Subject: Duke Energy Carolinas, LLC
William States Lee III Nuclear Station - Docket Nos. 52-018 and 52-019
AP1000 Combined License Application for the
William States Lee III Nuclear Station Units 1 and 2
Responses to Request for Additional Information
Ltr# WLG2011.06-03

Lee Nuclear Station Response to Request for Additional Information (RAI)

Reference NRC RAI Number: ER RAI 190 Supplement, Site Layout and Plant Description

Reference NRC RAI Number: ER RAI 210 Supplement, Ecology - Aquatic

River Water Intake Structure
Sheet 6 of 7
Figure 5.3-1, Rev 3

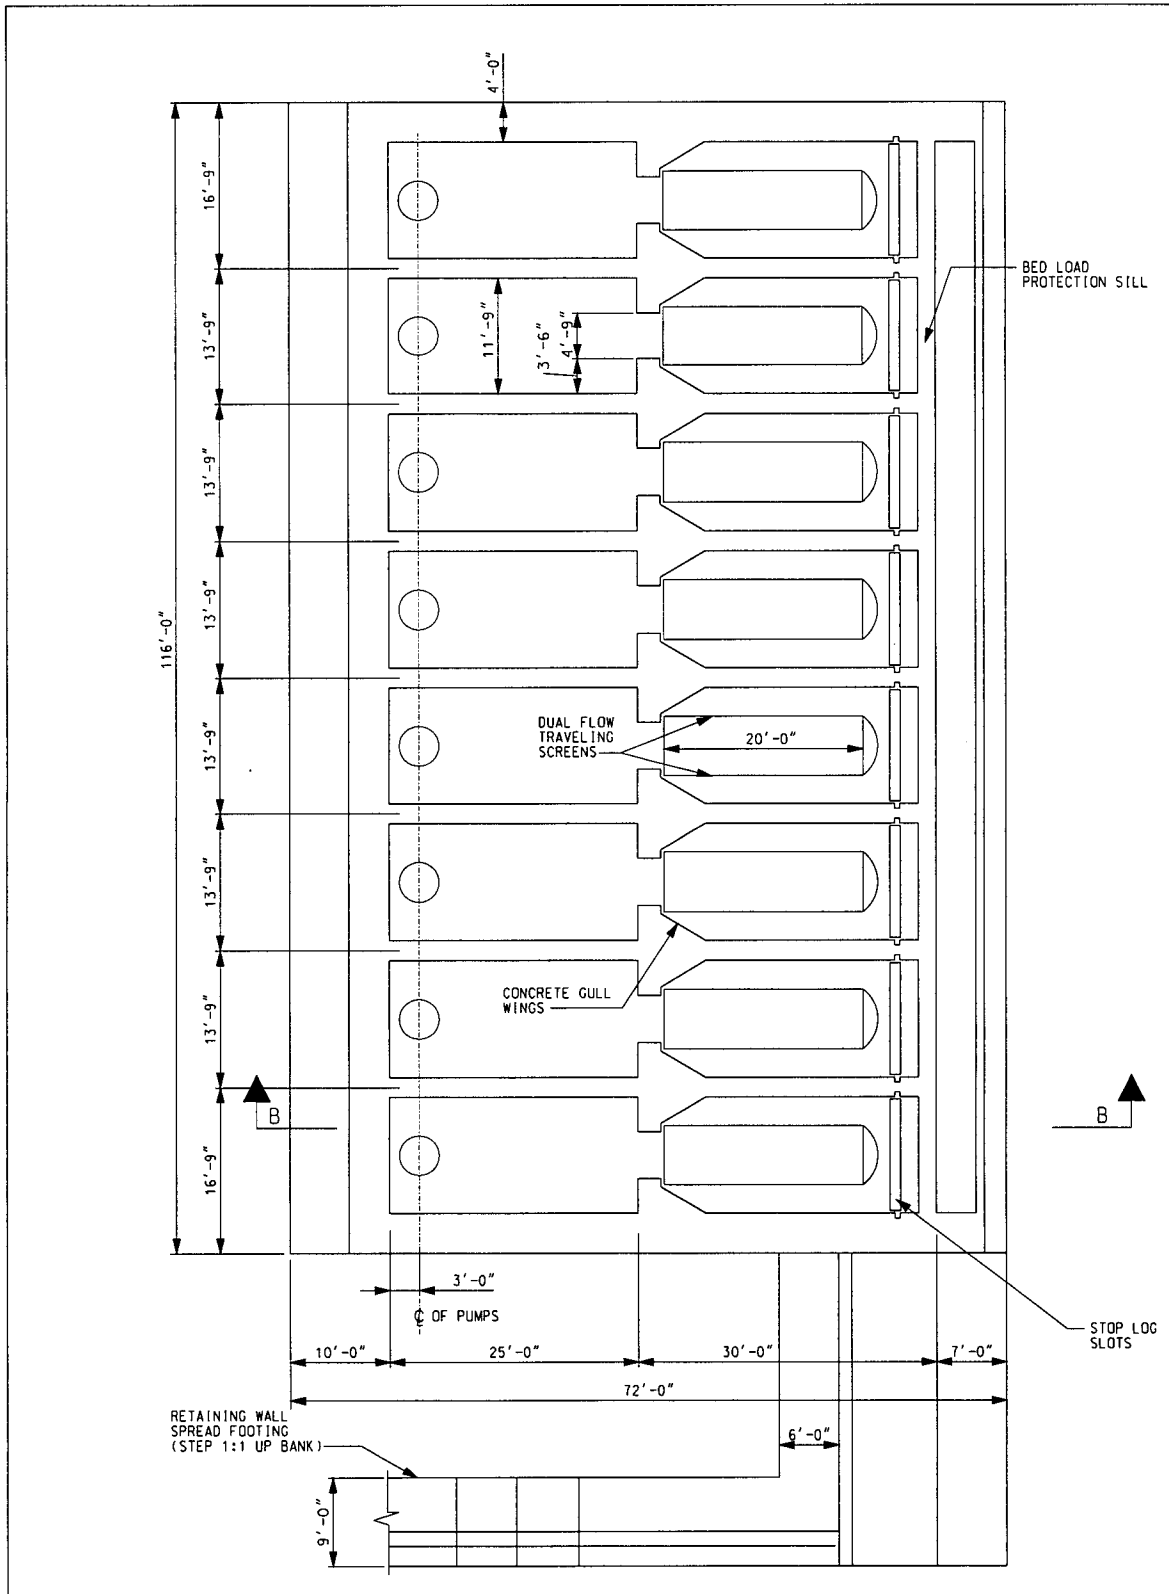
Provide physical descriptions (e.g., location, dimensions, construction materials, pump systems) of the "River Water Intake Subsystem" and the "Refill Subsystem Intake" referred to in Supplemental ER Figure 3.3-1, Sheets 1 and 2.

During a conference call on May 18, 2011 the NRC requested that figures be provided in RAI 190 be enlarged.

In addition to providing enlarged figures, the width of the Dual Flow Traveling Screens (refer to Mat Plan View @ El 497'-0" on updated ER Supplement Figure 5.3-1 Sheet 6 of 7 [Attachment 190S-01]) has been increased from 12'-4" to 20'-0" to provide additional design margin and to ensure through-screen velocity of the intake screens will be less than 0.5 feet per second. This change also results in the overall width of the River Water Intake Structure increasing by 8'-0".

Make-Up Pond A Intake Structure
Sheet 3 of 5
Figure 5.3-3, Rev 3

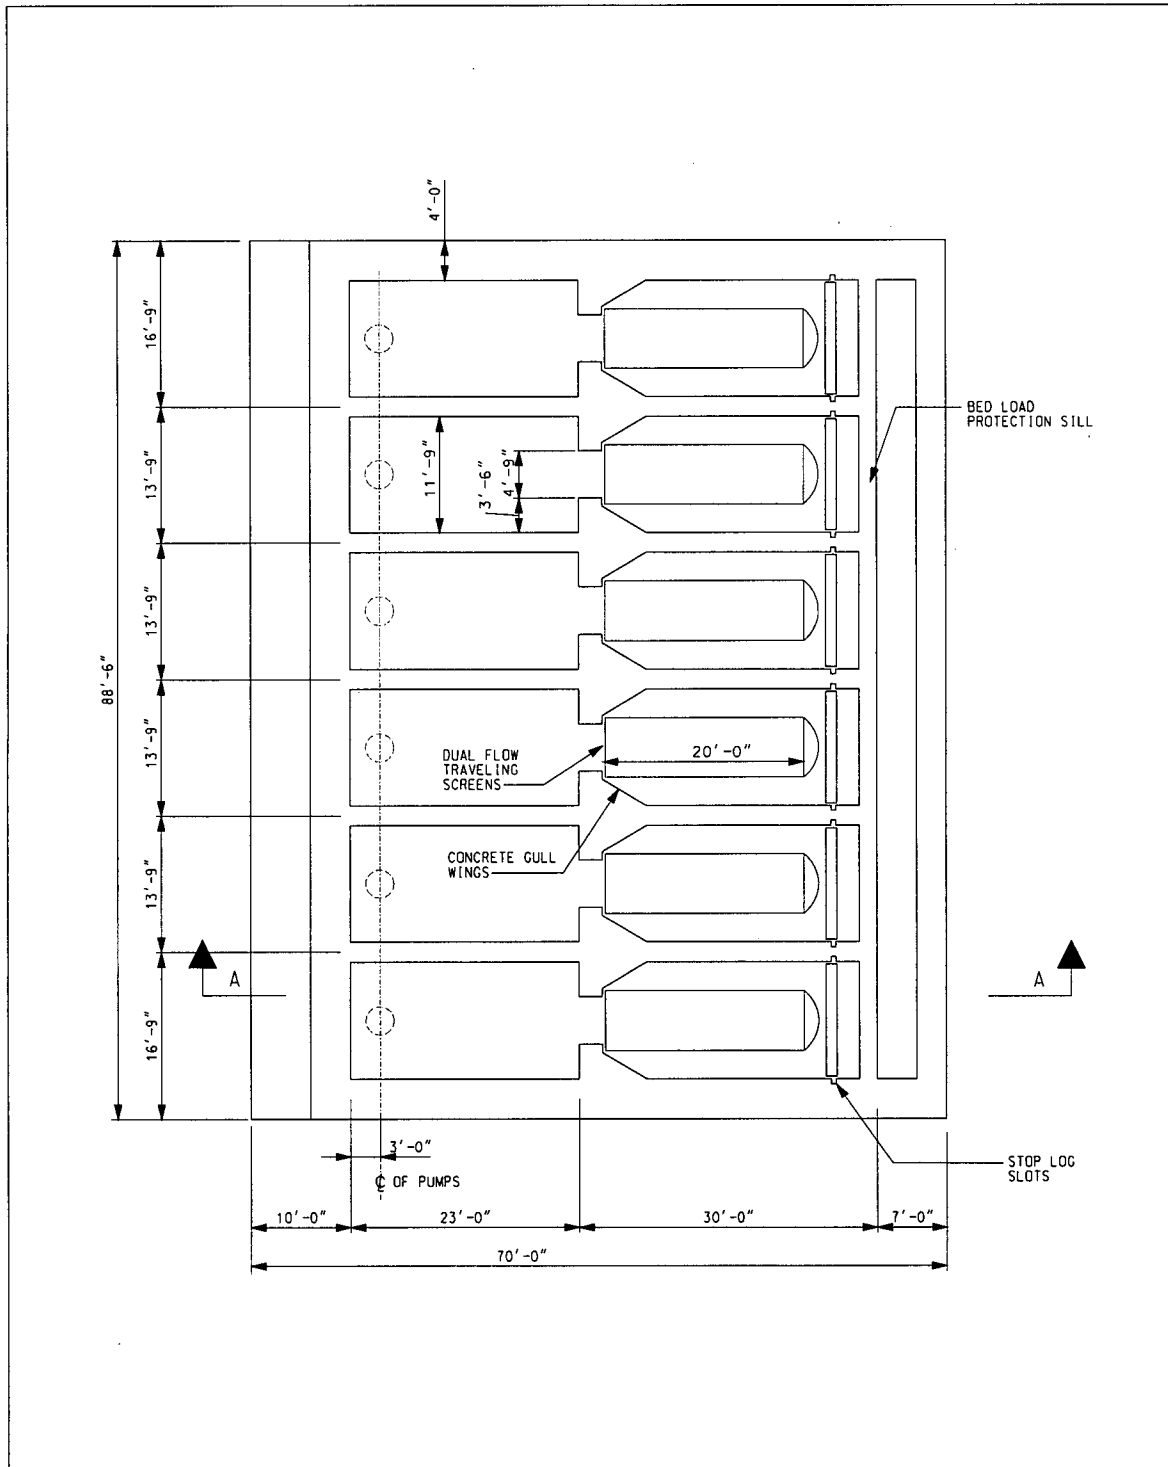
Provide bathymetric maps of Ponds A, B, and C that show clearly labeled contour lines with the locations of the intake screen and supporting structures superimposed. Provide plan and section views of each intake structure. For clarity and legibility, print the maps in black and white. Describe what is known about the options for wedge wire slot sizes for the traveling screens, particularly if an estimate or range of potential slot sizes is known. Provide information about the height the Pond B and C drum screens will be elevated above the substrate. Also, describe the potential cleaning methods for the Ponds A, B, and C intake screens. Indicate in the response when and how through-screen velocity calculations will be provided to the NRC (e.g., through submittal of a copy of the National Pollution Discharge Elimination System permit application).

During a conference call on May 18, 2011 the NRC requested that figures be provided in RAI 210 for Pond A be enlarged.

In addition to providing enlarged figures, the width of the Dual Flow Traveling Screens (refer to Mat Plan View @ El 510'-0" on updated ER Figure 5.3-3 Sheet 3 of 5 [Attachment 210S-01]) has been increased from 12'-4" to 20'-0" to provide additional design margin and to ensure through-screen velocity of the intake screens will be less than 0.5 feet per second. This change also results in the overall width of the Make-Up Pond A Intake Structure increasing by 8'-0".
